Inland Transport Committee

World Forum for Harmonization of Vehicle Regulations**Working Party on Passive Safety****Sixty-sixth session**

UN Global Technical Regulation No. 7 (Head restraints)**Proposal for Amendment 1 of Phase 2 of UN Global
Technical Regulation No. 7 (Head restraints)****Submitted by the Informal Working Group on the Phase 2 of UN
Global Technical Regulation No. 7***

Figure 1-1

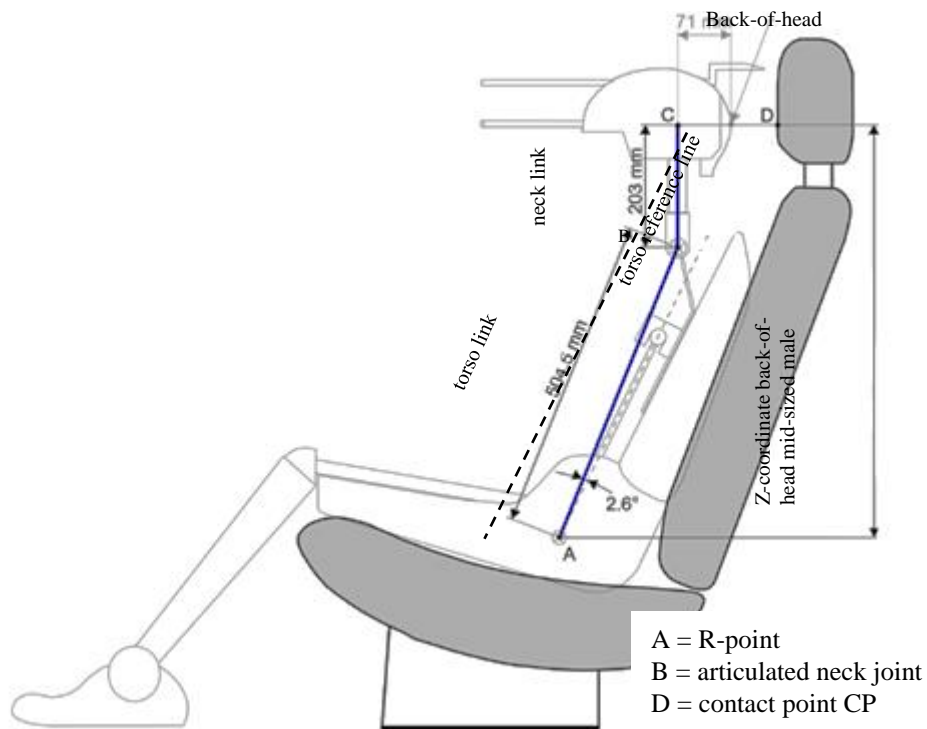
The height measurement apparatus consists of (see Figure 1-1): **shall be based on the use of an apparatus that facilitates the measurement of coordinates.**

The CP is defined as the intersection of a horizontal line, on the height of the Z-coordinate of the back-of-head of the mid-sized male (as given in table 1), with the front surface of the head restraint as indicated in Figure 1-1.

¹ The back-of-head of the mid-sized male is represented by the HRMD attached to the three-dimensional H-point machine, as well as by the Torso and Neck Link with the head room probe fitted 71 mm rearwards (see Figure 1-1)

Figure 1-3

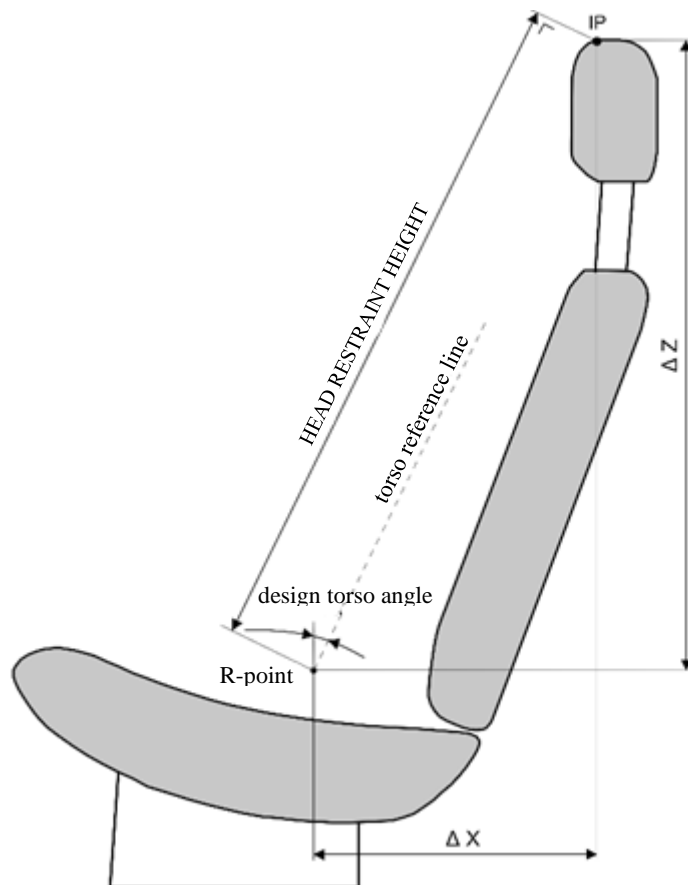
The head restraint height is the distance from the R-point, parallel to the torso reference line and limited by a line perpendicular to the torso reference line intersecting IP (see Figure 1-3).

After the coordinates of the IP are determined, the highest head restraint height can be calculated by its longitudinal (ΔX) and vertical (ΔZ) distance from the R-point (see Figure 1-3), as follows:

Figure 1-4

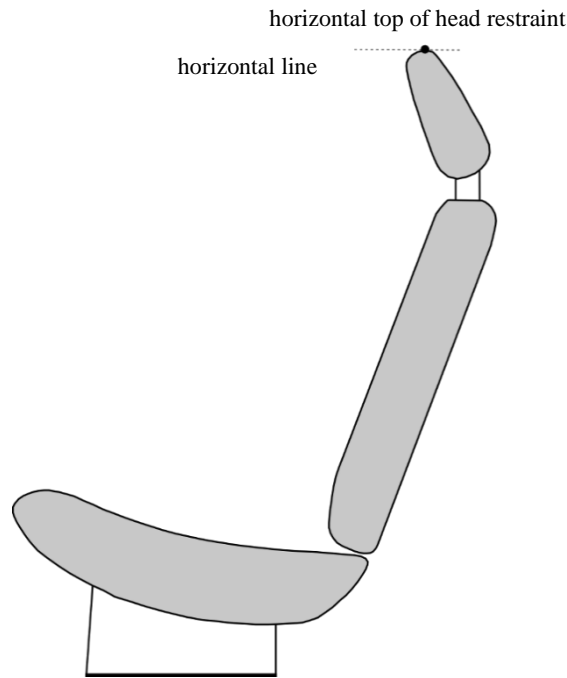
restraint, which is determined by lowering a horizontal line in the median longitudinal plane of the designated seating position until it touches the head restraint (see Figure 1-4). Where more points are located at the same height, the longitudinally forward most point of the horizontal top of the head restraint is designated as CP.

Where the IP would be located rearwards of the horizontal top of the head restraint, the IP will be designated at the horizontal top of the head restraint (see Figure 1-4).

Figure 8-1

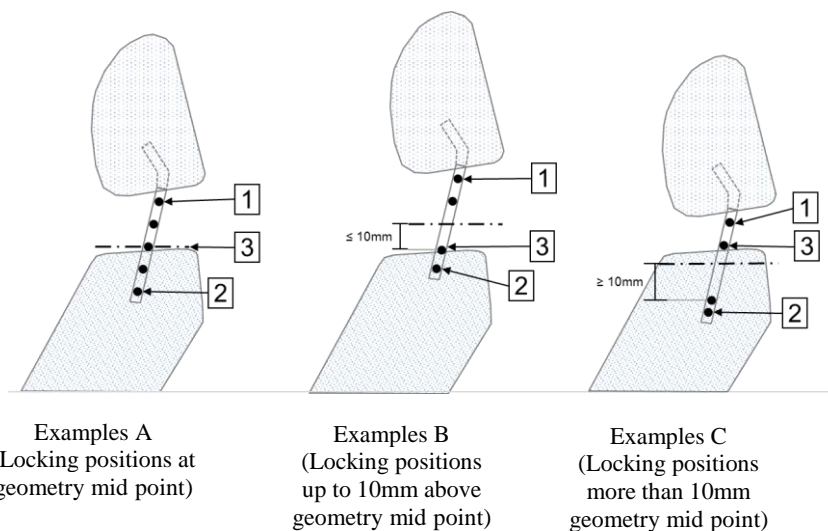
If a locking position exists within 10 mm vertically upwards from the geometric mid-position, this shall be the test position. If no locking position exists within 10 mm vertically upwards from the geometric mid-position then the next locking position downwards shall be the test position. This shall be determined from the top of the head restraint.

When the head restraint has a locking fore-aft adjustment, it shall be in the midpoint. If a locking position exists within 10 mm horizontally forward from the geometric mid-position, this shall be the test position. If no locking position exists within 10 mm horizontally forwards from the geometric mid-position then the next locking position rearwards shall be the test position, as shown in Figure 8-1.

Figure 8-2

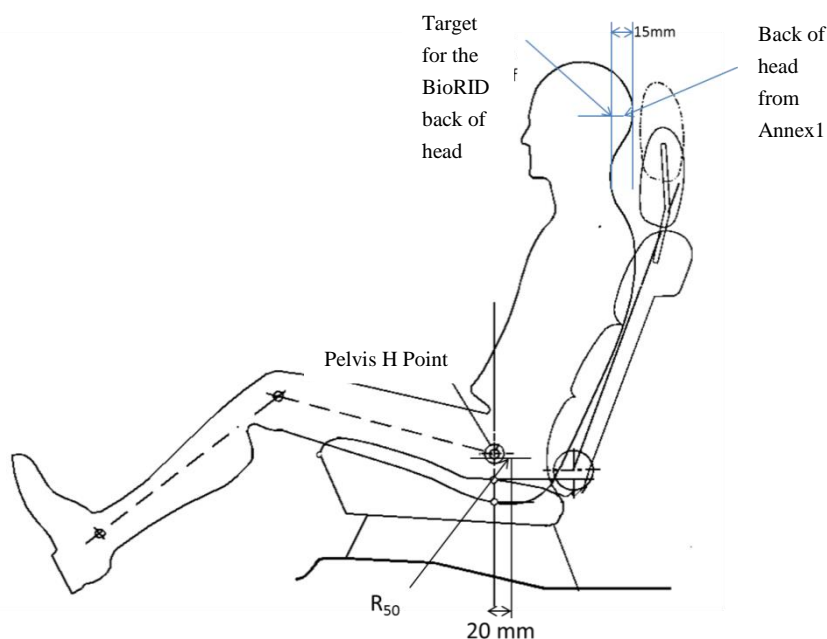
The back of the head reference position for the BioRID II is the value determined for the 50th percentile in Table 1, Annex 1 of this Regulation with reference to the specified torso angle minus 15 mm (increasing the backset as shown in figure 8-2).

3.2.7.6. The BioRID shall be installed such that its H-point is positioned 20 mm \pm 10 mm forward of the R₅₀-point, as shown in Figure 8-1, while keeping the pelvis angle within the range specified in paragraph 3.2.7.5. above.

Figure 9-1 8-3
Sled pulse acceleration corridor

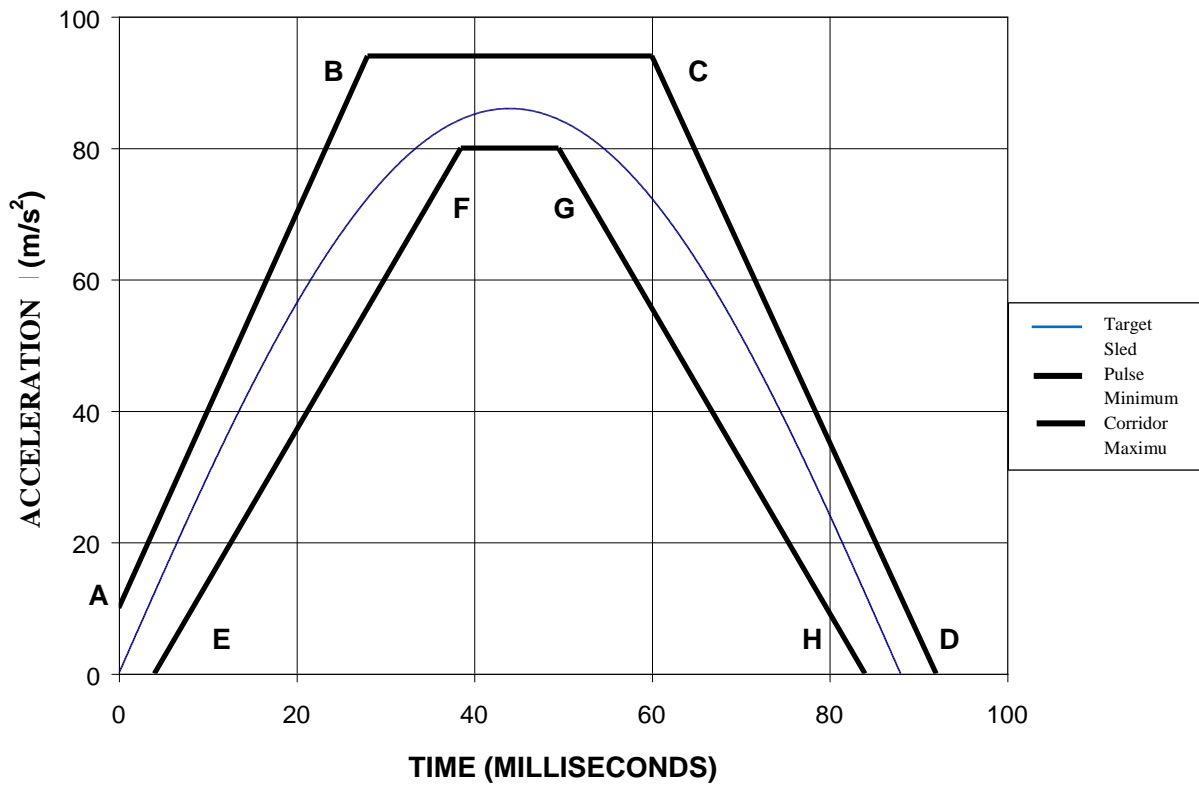
4.1. 4.1.1. Accelerate or decelerate the dynamic test platform to reach a delta V of 17.3 ± 0.6 km/h. All of the points on the acceleration vs. time curve fall within the corridor described in Figure 9-18-3 and Table 9-18-1 when filtered to channel class 60, as specified in the SAE Recommended Practice J211/1 (revision March 1995). Measure the maximum rearward angular displacement.
